84 East End Rd Charlton Kings Cheltenham

Application Ref 23/00430/FUL

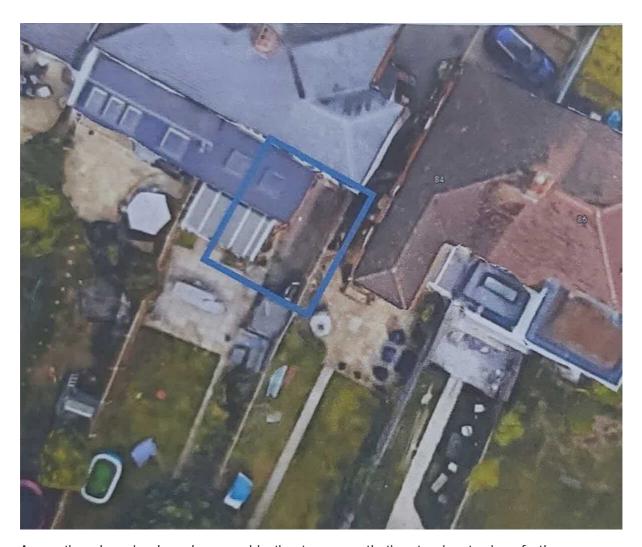
The alterations proposed are below and the measurements are so minimal, we are talking mm's, that they will give little if any improvement to the daylight and amenity at no.84. Again a daylight survey would have confirmed this had it been carried out.

A reduction in the width of the extension resulting in the extension being set in from the existing side elevation by 225mm

A reduction in the eaves height of the two storey extension by approximately 400mm

A reduction in the ridge height of the proposed two storey extension by approximately 600mm
